Chesapeake modifications to Regional Standards Third Edition

DESIGN AND CONSTRUCTION STANDARDS			
		FIRE HYDRANT SETTING (TYPE III)			
DR. BY:	DATE:	WD_08	09		
08/15/03	REV. FOR INTERNET 2003			CHK. BY:	DATE:
DATE	REVISIONS			APP. BY:	DATE:

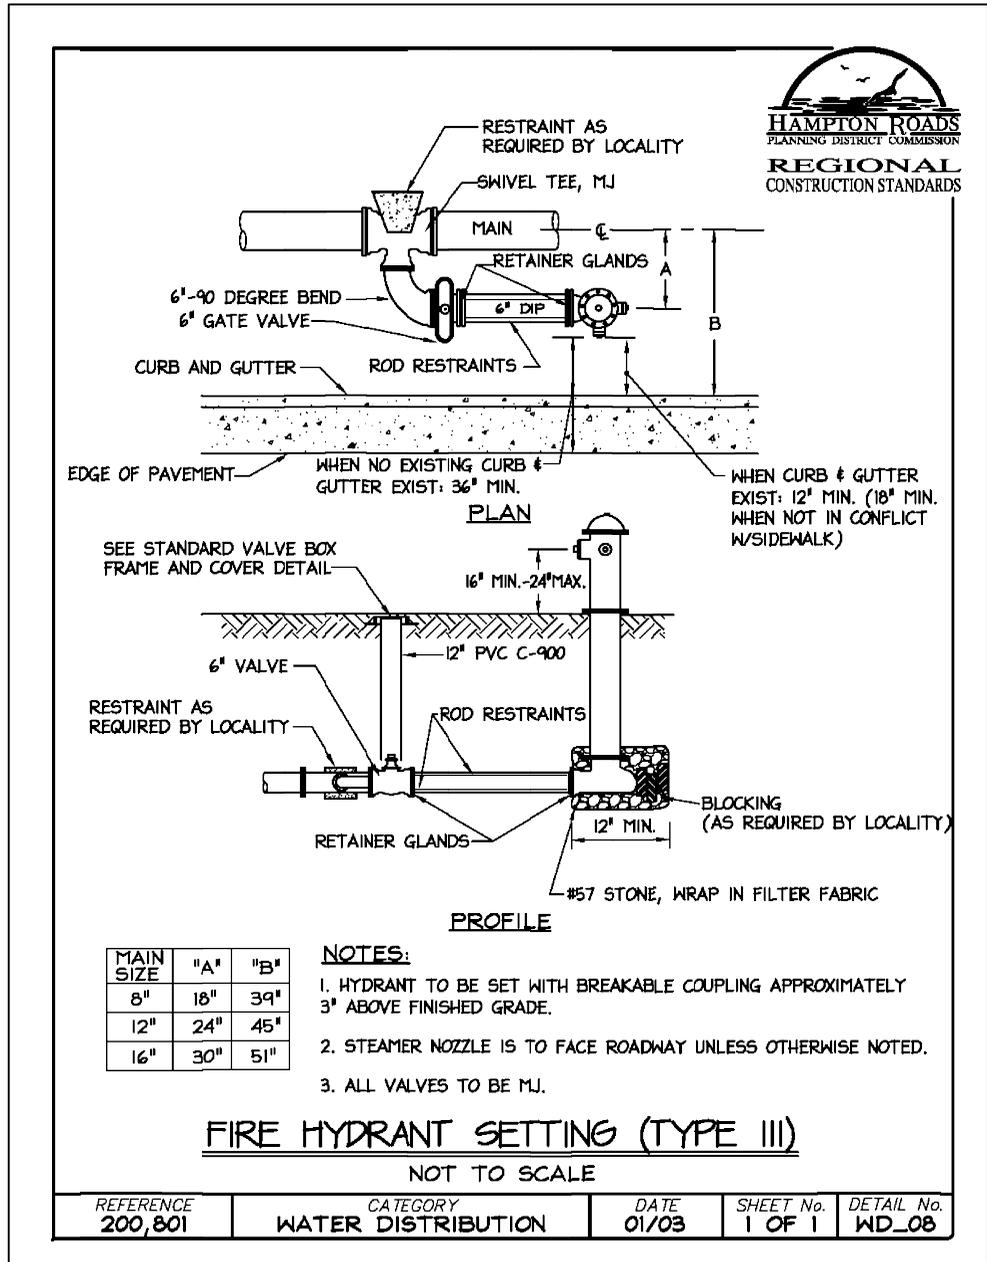
1. No thrust block to be installed on the tee for the hydrant.
2. Valves to be MJ X MJ and located 3 feet from the water main.
3. Minimum distance behind curb to be 18 inches.
4. 90° bend to be MJ X MJ. Foster Adaptors may be used at each end.
